Title - Sujet Hatchery Complex Construction	
Solicitation No. - N° de l'invitation F1700-150669/A	Amendment No. - N° modif. 003
Client Reference No. - N° de référence du client F1700-150669	Date 2016-01-29
GETS Reference No. - N° de référence de SEAG PW-\$PWY-028-7723	
File No. - N° de dossier PWY-5-38345 (028)	CCC No./N° CCC - FMS No./N° VME
Solicitation Closes - L'invitation prend fin at - à 02:00 PM on - le 2016-02-05	
F.O.B. - F.A.B. Plant-Usine: <input type="checkbox"/> Destination: <input checked="" type="checkbox"/> Other-Autre: <input type="checkbox"/>	
Address Enquiries to: - Adresser toutes questions à: Lam (PWY), Tian	Buyer Id - Id de l'acheteur pwy028
Telephone No. - N° de téléphone (604) 775-9382 ()	FAX No. - N° de FAX (604) 775-6633
Destination - of Goods, Services, and Construction: Destination - des biens, services et construction: DFO - Snootli Creek Hatchery - Bella Coola, BC

Hatchery Complex Construction
Snootli Creek Hatchery, Bella Coola, B.C
Solicitation No: F1700-150669/A

ANSWERS TO QUESTIONS RAISED BY BIDDERS

SCALE: AS SHOWN
 DATE: 2015-10-20
 DRAWING NUMBER: **A-209**
 REVISION: 2

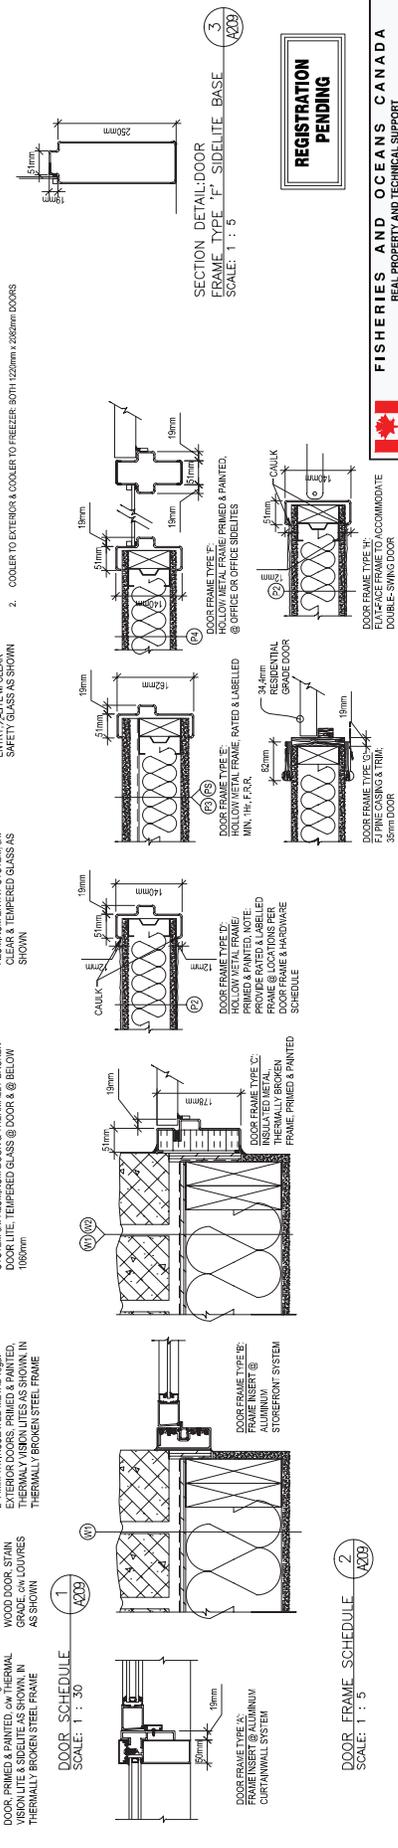
Q1. Are we going to get a hardware schedule for the door ?

Q2. On drawing 209, door, frame and hardware schedule, it shows hardware groups 1 thru 16, yet in 08 71 00 Door Hardware, there is only 3 hardware groups shown. Will you be issuing a new hardware schedule by addendum ?

A1. Hardware Schedule is located on attached Revised Drawing No. 24 (A-209: Doors, Frames and Hardware). Also refer to Q2. Below.

A2. See attached Drawing 24: A-209 Door Frames & Hardware (Rev.2) 2016-01- 28 with new Door Frame & Hardware Schedule.

The following Hardware Groups are referenced in the above referenced Drawing 24 and supercede those listed in Technical Specification Section 08 71 00:
